KWM-380 TRANSCEIVER (622-5093-101)
HF-380 TRANSCEIVER (622-3580-101)
RECEIVER-EXCITER CIRCUIT CARD A3 (638-6908-001)

SERVICE BULLETIN NO 1**PRODUCT IMPROVEMENT**

This is a nonmandatory service bulletin which applies to the following:

P/O Receiver-Exciter Circuit Card A3

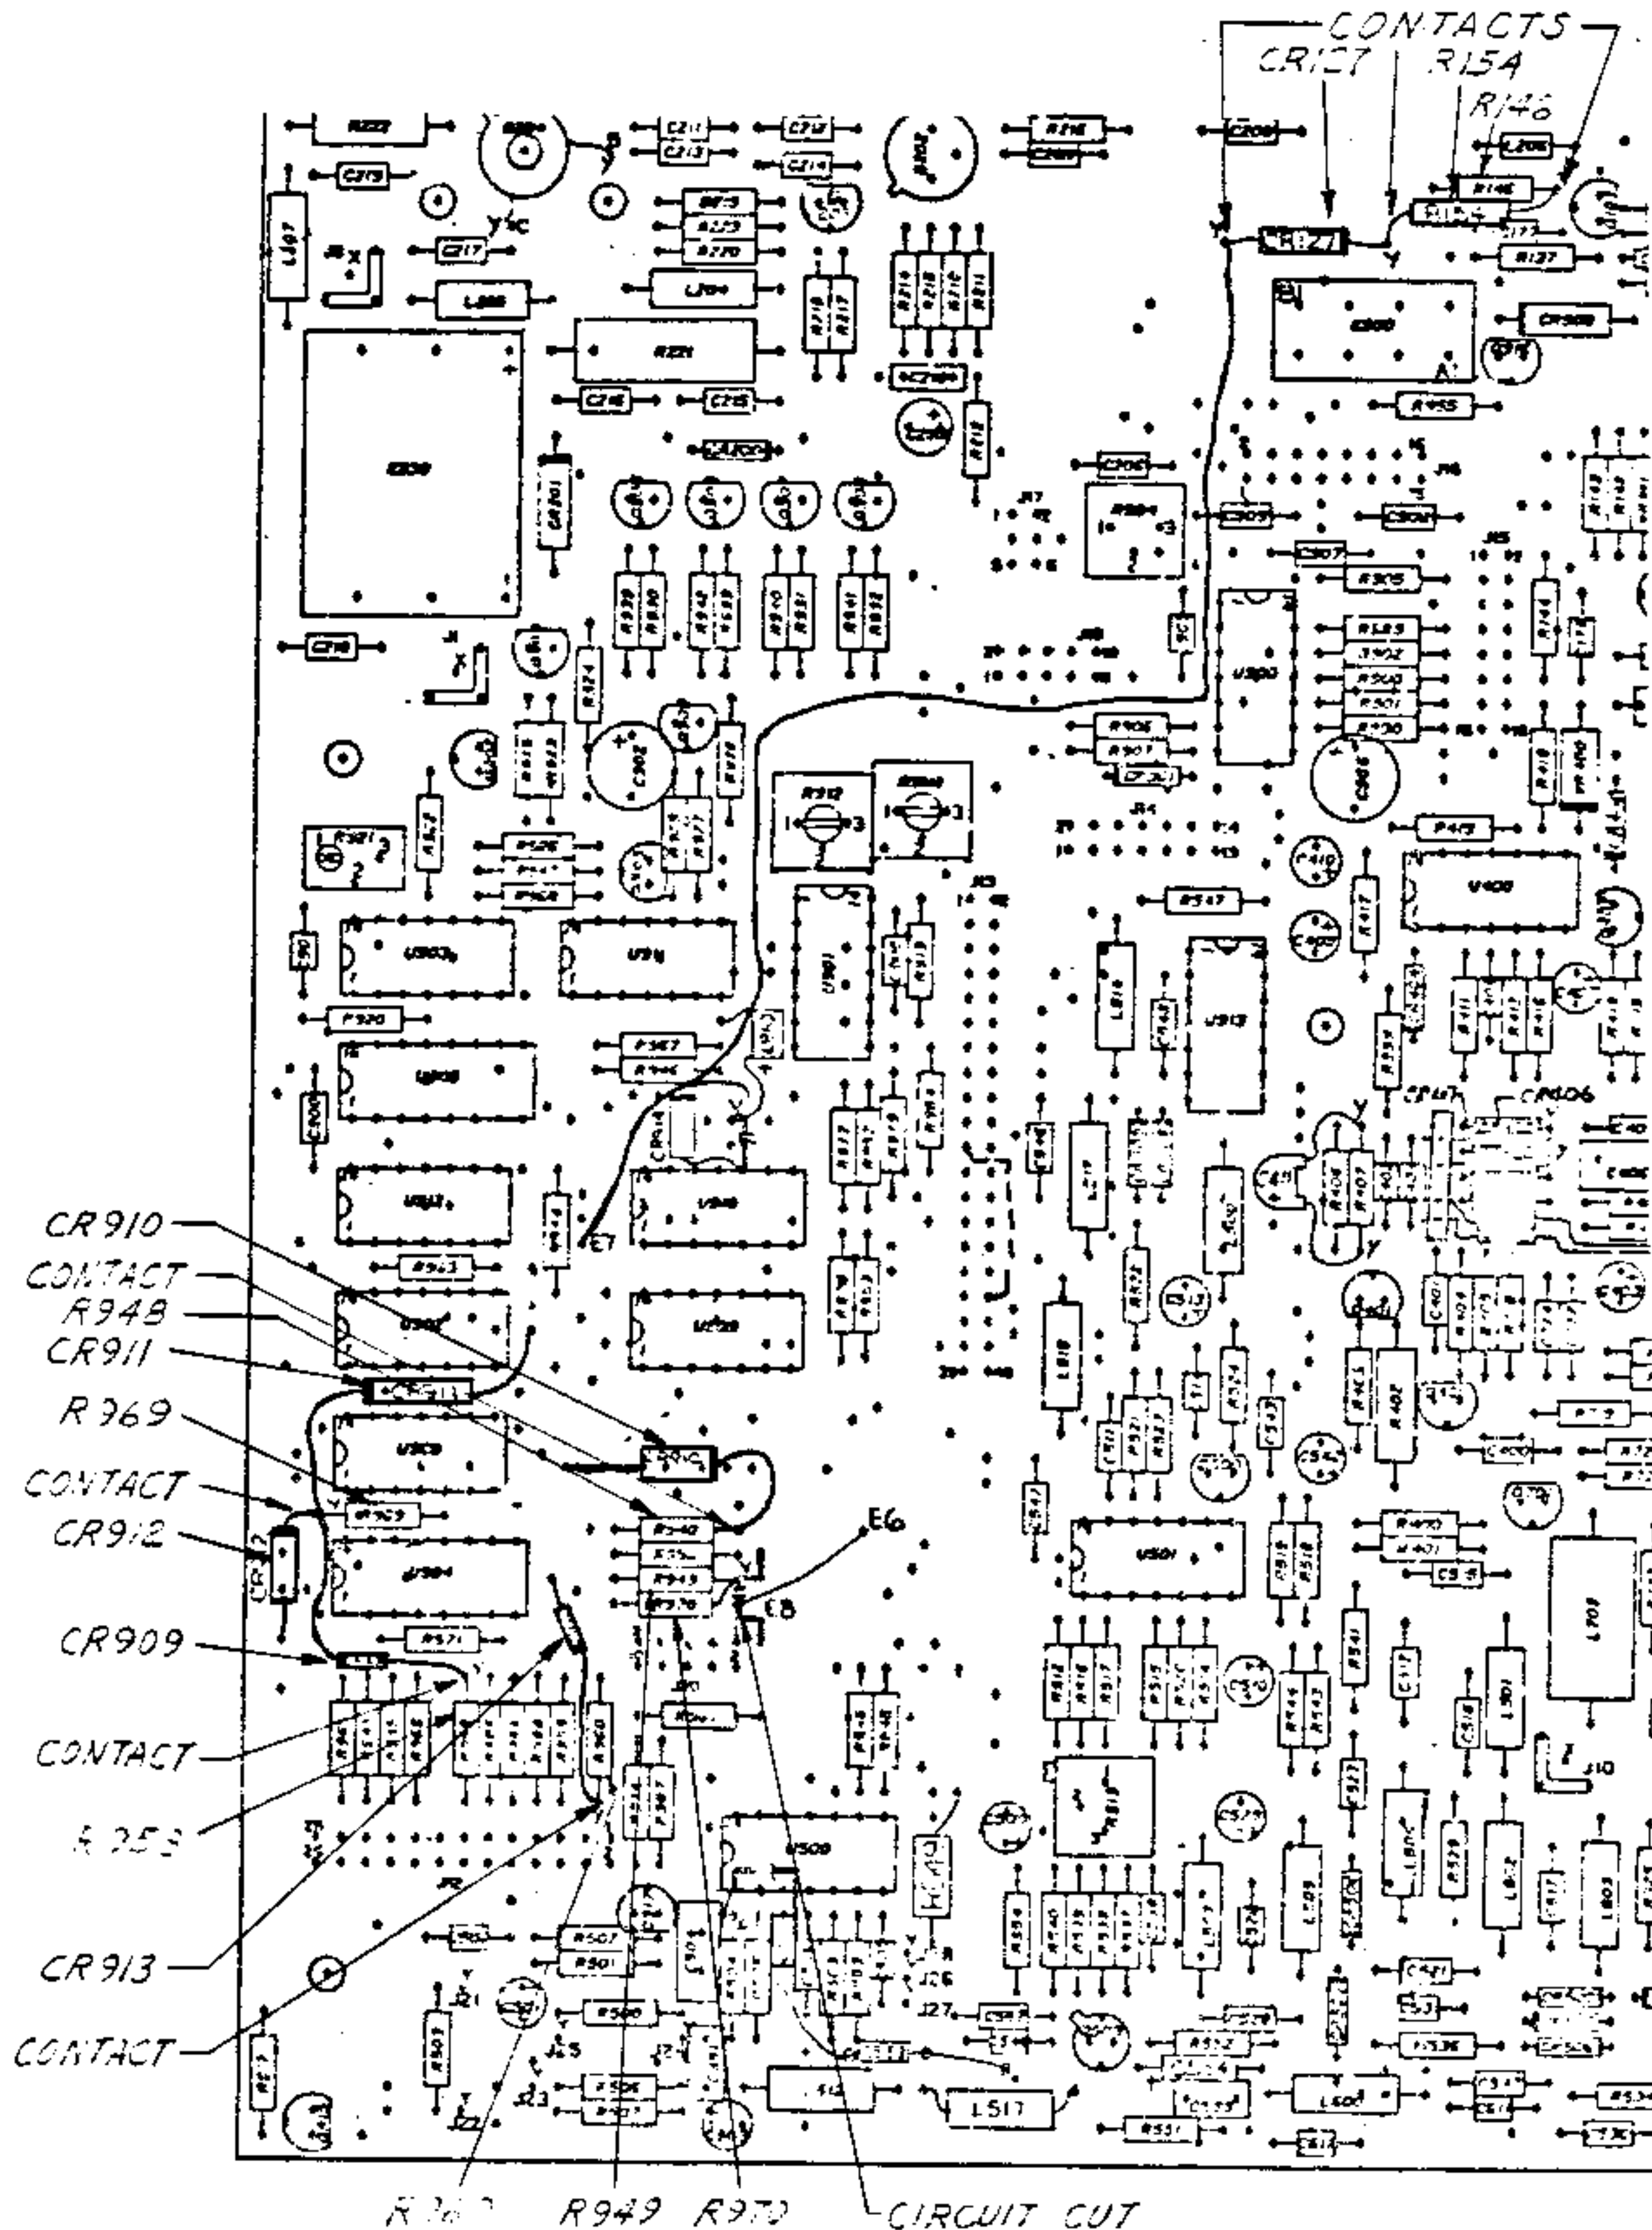
- D. Cut the circuit trace that connects R970 and R949 right-hand leads as shown in figure 1. Cover the circuit trace cut with a nonconductive material such as epoxy.

- K. Connect the R960 lead to the new contact.
- L. Install 1N4454 diode CR913 (353-3644-010) as shown in figure 1 with the cathode end connected to the contact installed in step J. Solder connections on both ends.

- Q. Install 1N4454 diodes CR911 and CR912 (353-3644-010) as shown in figure 1 with the cathodes connected to R969. Solder all connections.
- R. Unsolder and lift the right-hand lead of resistor R948.

- S. Install and solder a contact (372-2601-045) in the hole where the R948 lead was removed.
- T. Connect the R948 lead to the new contact.
- U. Install 1N4454 diode CR910 (353-3644-010) as shown in figure 1 with the cathode end connected to the contact installed in step S. Solder all connections.

- V. Unsolder and lift the right-hand lead of resistor R146.
- W. Install and solder three contacts (372-2601-045) in the vicinity of R146 as shown in figure 1.

- X. Connect the R146 lead to one of the new contacts as shown in figure 1.
- Y. Install 100-k Ω resistor R154 (745-0821-000) between two of the new contacts as shown in figure 1.

- Z. Install 1N4454 diode CR127 (353-3644-010) as shown in figure 1 with the cathode end connected to R154.
- AA. Install a #30 AWG jumper wire (428-0282-050) from E7 to the anode end of CR127. Solder all connections.
